**REMARKS**

This Amendment, submitted in response to the non-final Office Action dated December 8, 2004, is believed to be fully responsive to the points of rejection raised therein. Accordingly, favorable reconsideration on the merits is respectfully requested.

Ser.No.:  
 Inventor(s): R. S. Bunker  
 Docket No.: 120478  
 Attorney: P. Clarke  
 Telephone: (518) 387-5349

**Fig. 1**

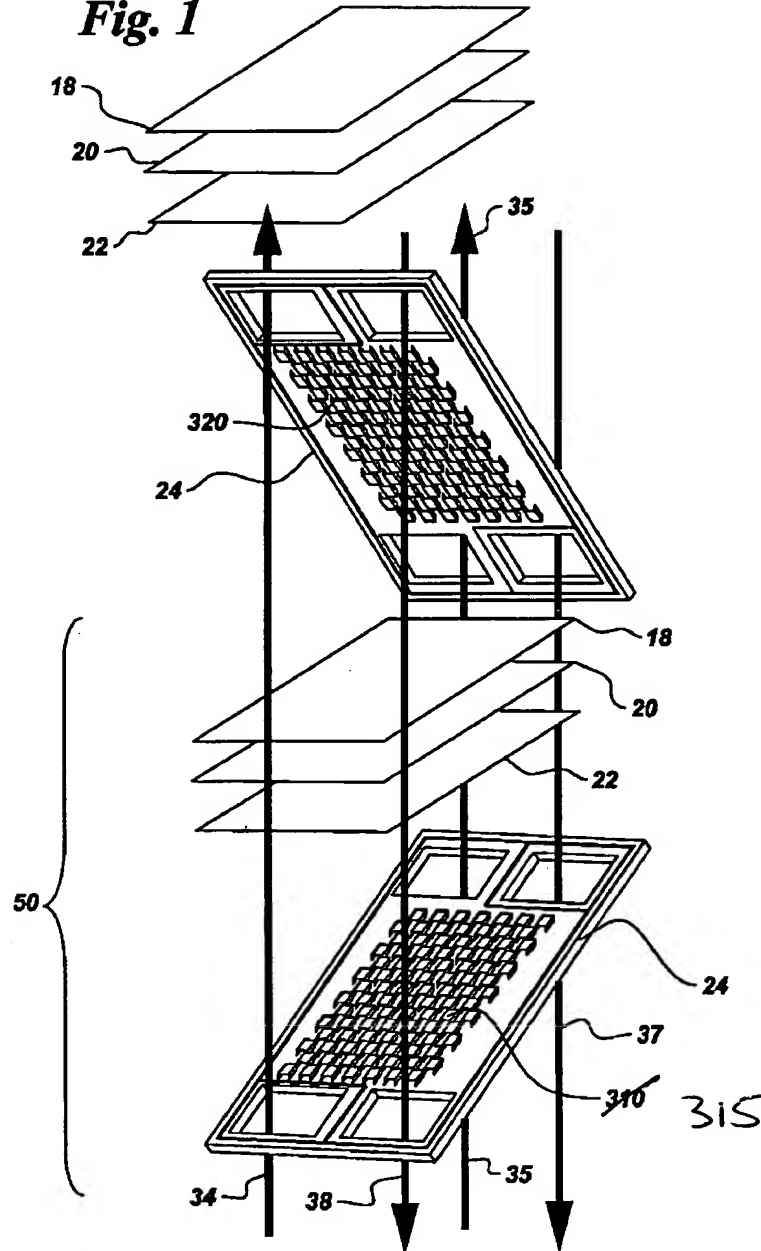
The Examiner objected to FIGS. 1 and 2. As requested by the Examiner, FIGS. 1 and 2 have been labeled as prior art, in that they merely illustrate exemplary internally and externally manifolded fuel cell stacks.

On page 4 of the office action, the Examiner objected to the specification for informalities regarding certain reference numbers. FIG. 1 has been amended to replace reference number 310 with 315, as indicated in Paragraph 22. Paragraph 24 is amended above per the Examiner's suggestion.

PRIOR ART

**Fig. 3**

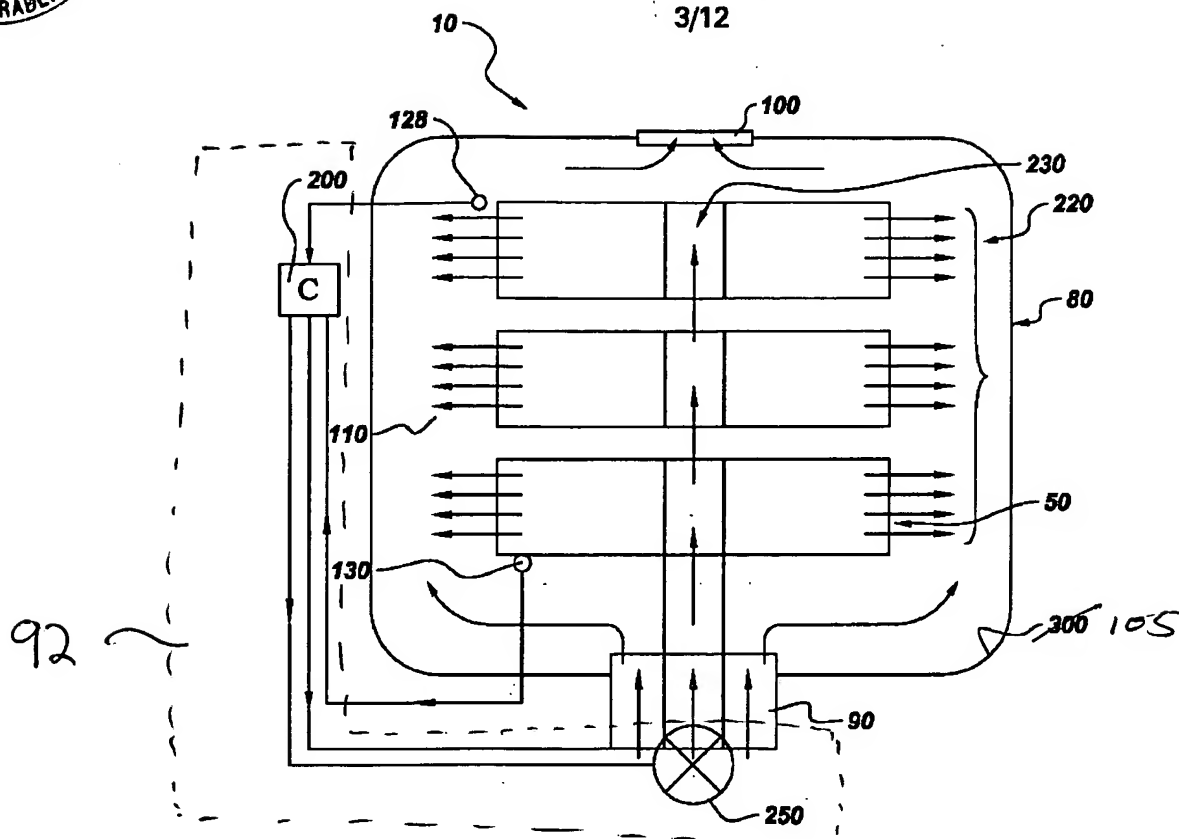
The Examiner objected to FIGS. 3, 5 and 12 for including reference number 300. Reference number 300 has been replaced in FIGS. 3, 5 and 12 by reference number 105. Reference number 105 has also been added to FIG. 6. Support for the amendments can be found, for example, in paragraph 28 on page 7 of the present application. Reference numeral 92 has also been added to FIGS. 3 and 12.

**Fig. 6**

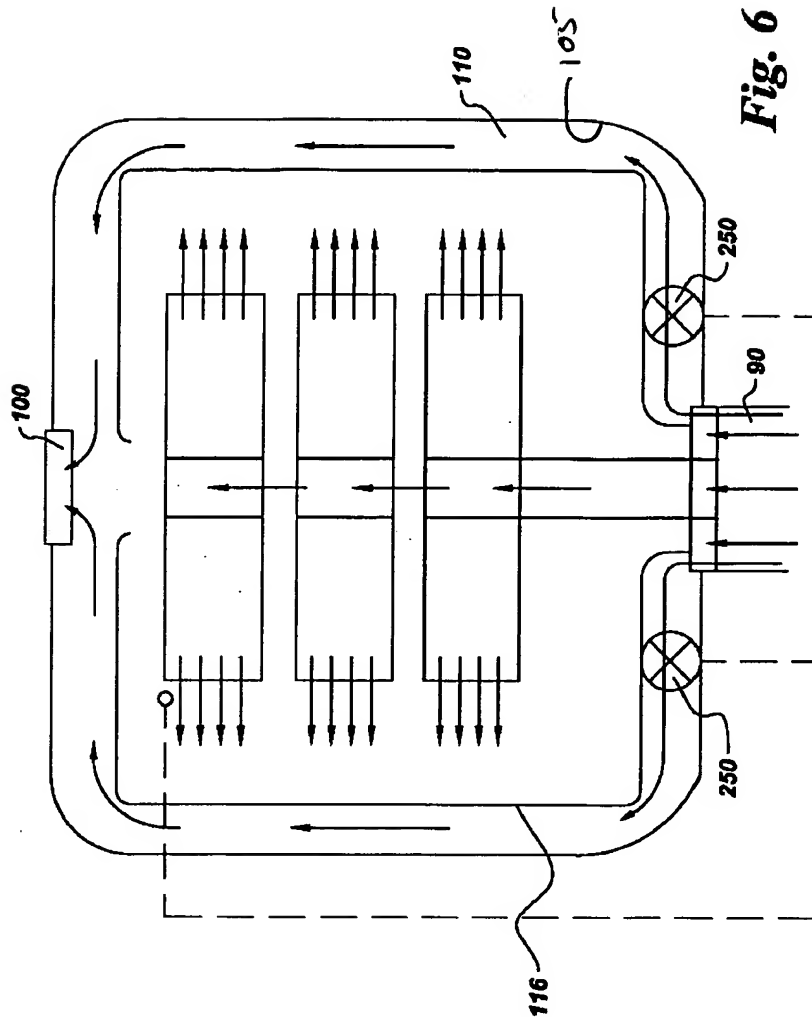
The Examiner objected to FIGS. 6 and 10 for including reference number 250. However, flow regulators 250 are discussed in paragraphs 25 (page 6) through paragraph 27 (page 7) of the present application.

**Fig. 7**

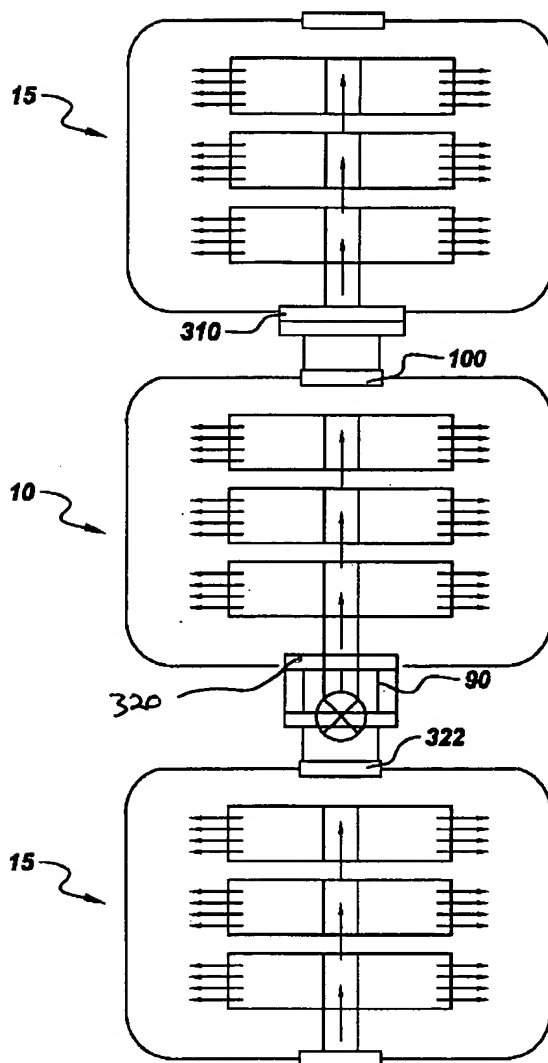
The Examiner objected to the drawings for failing to include reference numbers 105, 113 and 320. As noted above, reference number 105 has been added to FIGS. 3, 5, 6 and 12. Reference number 320 has been added to FIG. 7. Support for this amendment can be found in paragraph 29 on page 8, for example. FIG. 10 has been corrected to replace reference number 100 with reference number 113, to indicate the bypass flow exit of this embodiments, as described in paragraph 28 on page 7 continuing to page 8.

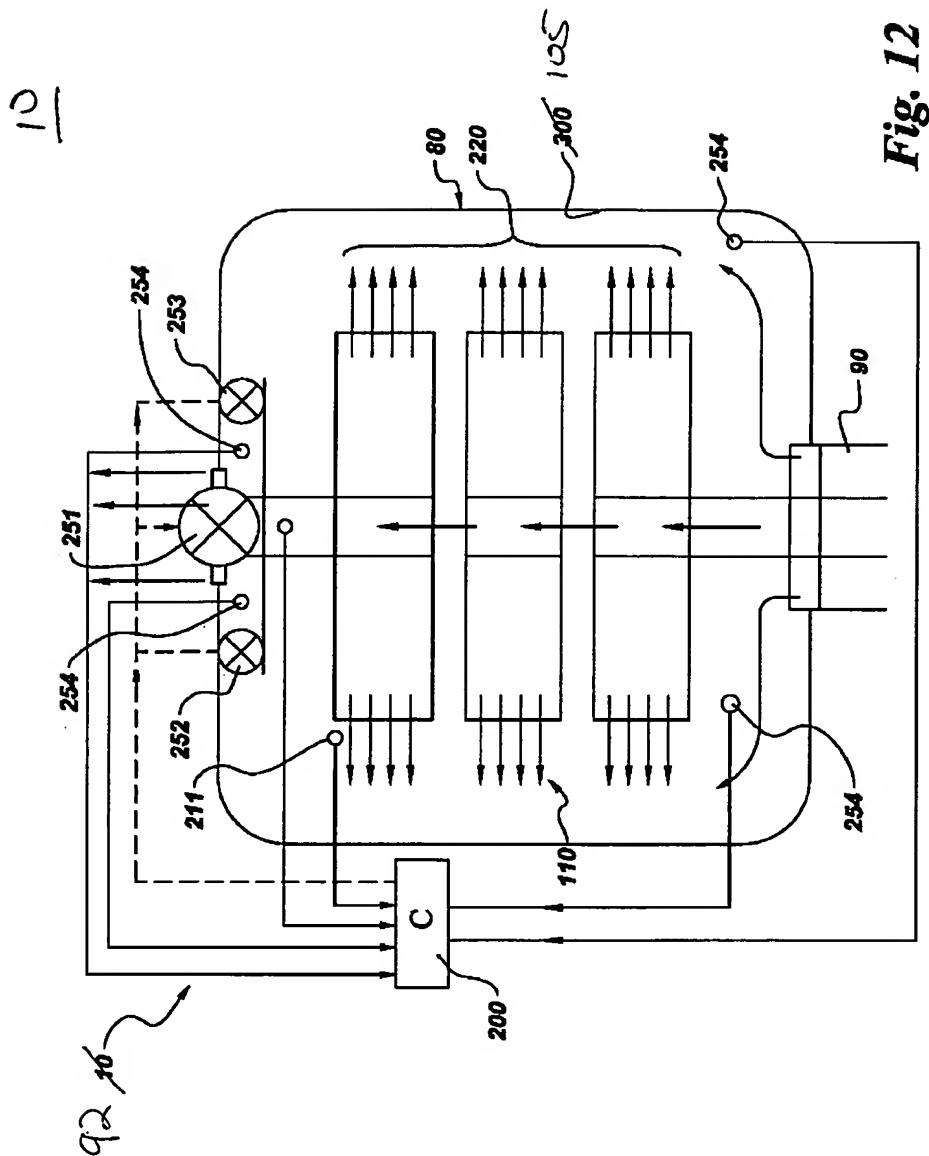
The Examiner objected to the drawings for using reference number 251 to designate both flow regulator and control sensor. Paragraph 31 on page 9 is amended above to replace 251 with 211, as shown in FIG. 12.
